## JAR-22: SAILPLANES AND POWERED SAILPLANES

Please find attached a copy of Amendment 1 to JAR-22, effective 1 August 2001.

**JAR-22, Amendment 6, 1 August 2001**

**FIGURE 1 MANOEUVRING ENVELOPE**

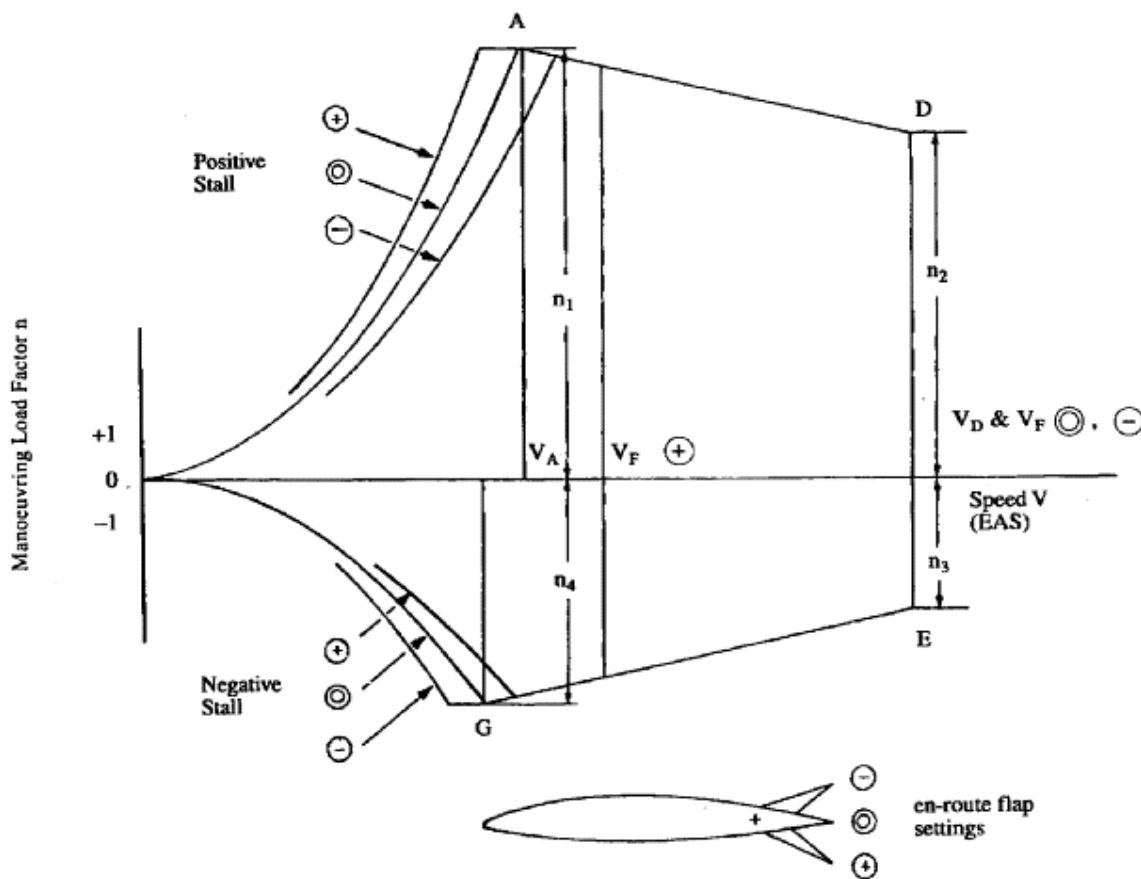
- (a) The introduction of NPA 22C–6, which:–
- (i) corrects the signs in the 'Load Factor Increment' column in the table of Category A – Additional Cases on page C–8; and
  - (ii) indicates manoeuvring load factors  $n_1$  to  $n_4$  in Figure 1, Manoeuvring Envelope, referred to in paragraph JAR 22.333(b).

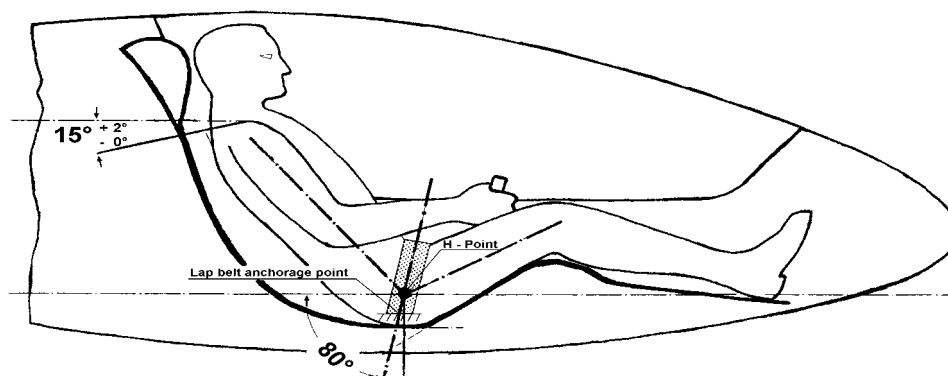
(3) The anchorage points of the shoulder belts should be located below and behind the pilots shoulders at an angle of  $15^\circ +2^\circ/-0^\circ$  to a line parallel to the longitudinal axis of the sailplane for a 50 percentile male. The lateral separation should be not more than 200 mm.]

**FIGURE 1 EXAMPLE OF AIR SPEED INDICATOR MARKINGS**

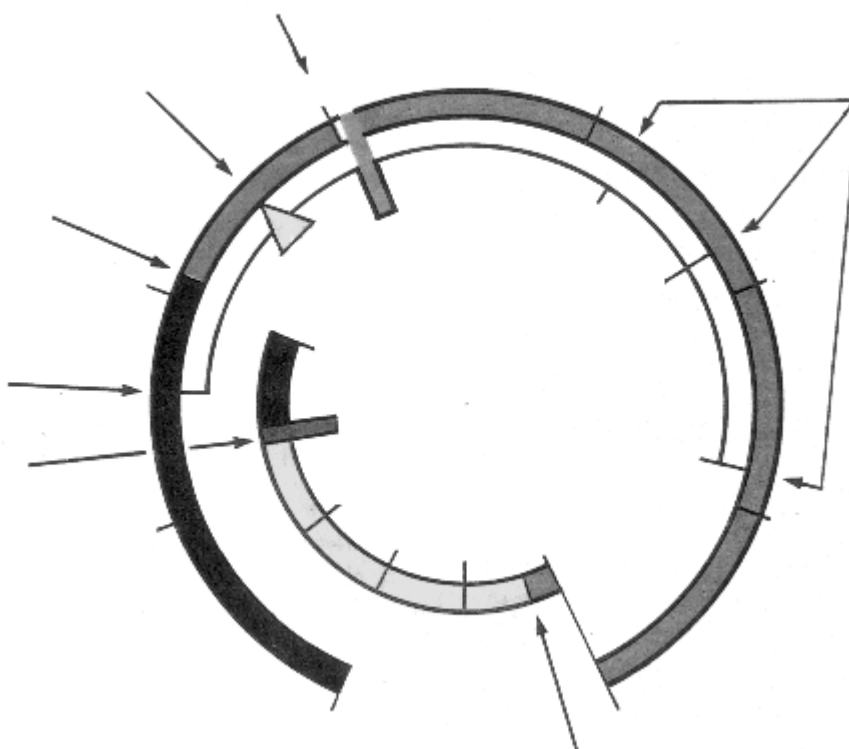
Editorial amendment to the caption of Figure 1 to clarify that the Figure is an example of airspeed indicator markings.
